# CITY PLANNING COMMISSION

- APPLICATION:
1. Environmental Determination
  2. Lot Line Adjustment to merge two parcels into one 0.4± acre site for parking lot development
  3. Variance to waive six foot solid masonry wall on east property line (Section C-5)
  4. Special Permit to allow a parking lot in the Garden Apartment-Review (R-2A-R) zone (Section 2-B-28)

LOCATION: 1927 and 1929 Wentworth Avenue

PROPOSAL: The applicant is requesting the necessary entitlements to develop a parking lot in a residential zone to accommodate overflow parking during peak hours and provide employee parking for Raley's Market.

**SITE PLAN**  
SCALE 1"=50'-0"

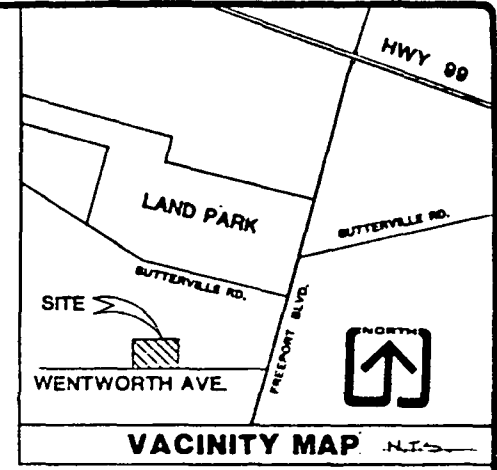
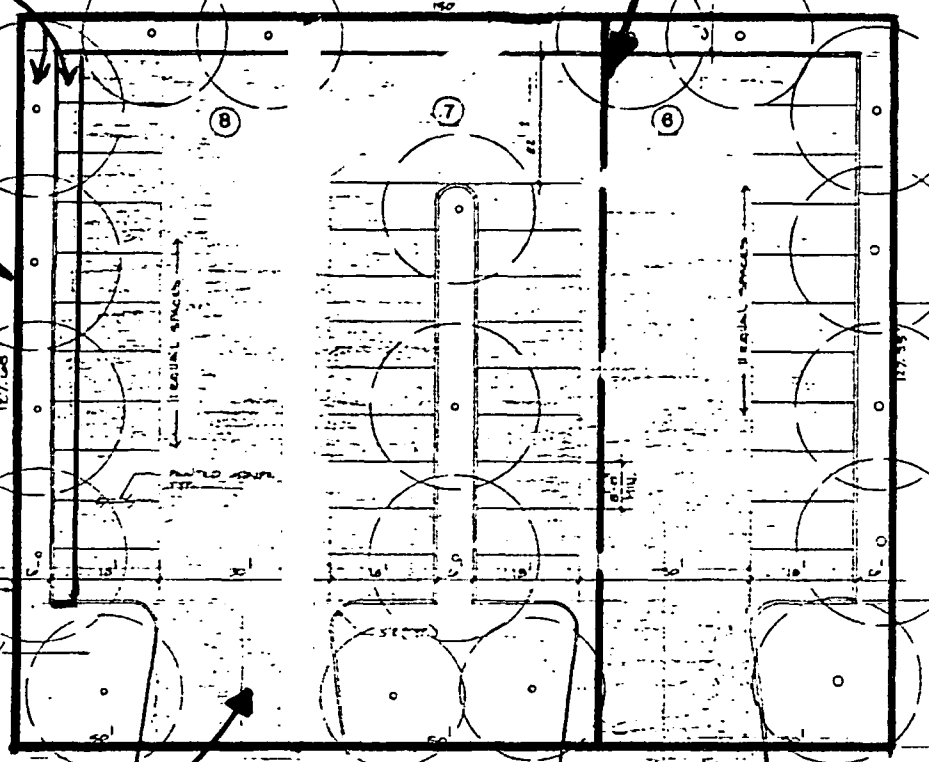
7. Staff has a concern regarding the location of the driveway near the single family residence. Staff suggests the westerly driveway be eliminated and replaced with landscaping. This will locate the parking ingress/egress farther away from the residential area and additional planting will provide a better transition between the residential and parking lot uses (see exhibit C).

8. To increase the buffer along the westerly property line, the six foot planting strip indicated on the site plan should be increased to 12 feet in width. This can be attained by reducing the parking stall depth from 18 feet to 16 feet and reducing the maneuvering space from 30 feet to 26 feet. This planting strip should be heavily landscaped with shrubs and trees (see exhibit C).

INCREASE  
PLANTER  
WIDTH  
12 FEET

REMOVE  
DRIVEWAY

- c. The applicant shall eliminate the westerly driveway entrance and replace with landscaping. Revised plans shall be submitted to the City Traffic Engineer and Planning Director for review and approval prior to issuance of building permits.

- d. The applicant shall provide for a 12 foot wide planter strip along the westerly side of the property as indicated in exhibit C. This planter shall be heavily landscaped with shrubs, ground cover and trees.
